BID ADDENDUM NO. 1 for Mexico City Avenue Interchange Improvements MoDOT Project No. KU0302

REQUEST FOR BID

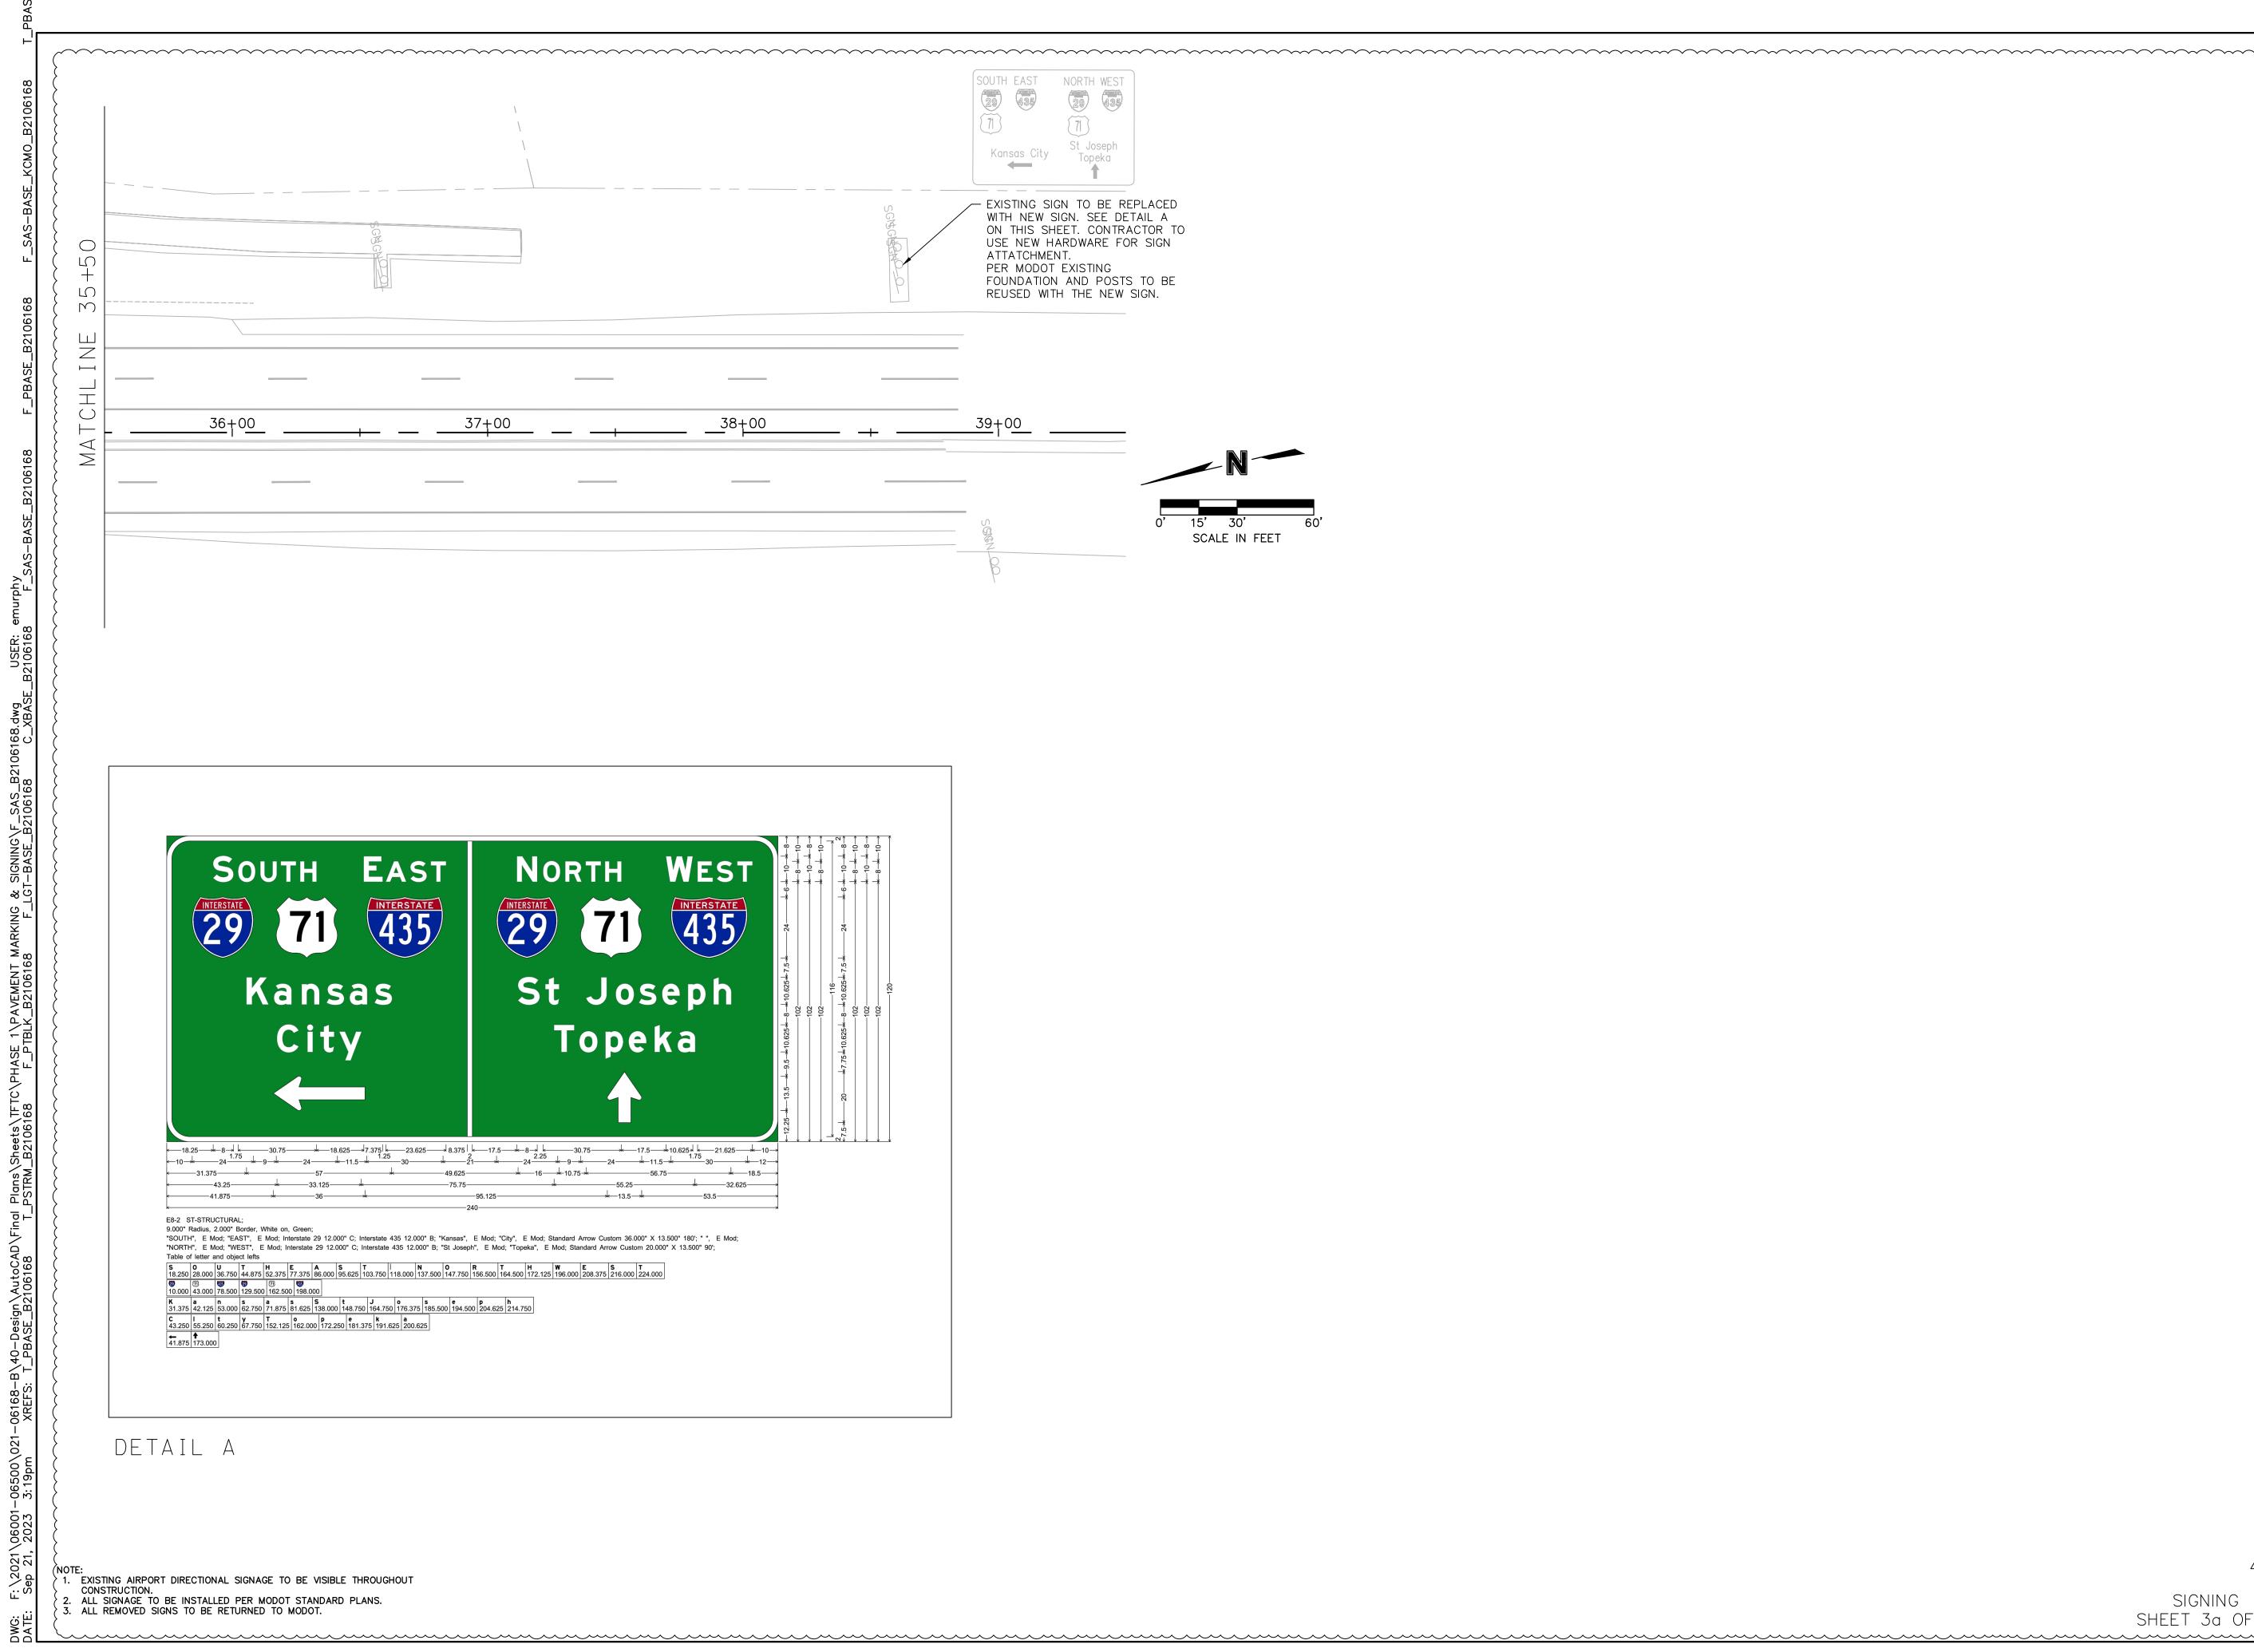
Item #	Location	Clarification/Description of Change
1	General	Contractors shall assume that any necessary import material will be available within 1,000 yards of the project site and will NOT require over-the-road hauling.
2	Sheet 42	Type A2 shoulders may be constructed of either HMA or PCC. The PCC alternative shoulder shall include a sawcut edge of the HMA pavement. No direct pay will be made for the sawcut. (RE: MoDOT Standard Plan 401.00C)
3	Sheets 112 to 114	For signs noted on the plans to be removed and relocated on new post assembly, the type of new sign post shall match existing. For new sign assemblies, the sign post type shall conform to MoDOT EPG.
4	Sheet 114A	ADD Sheet 114A – SIGNING PLAN
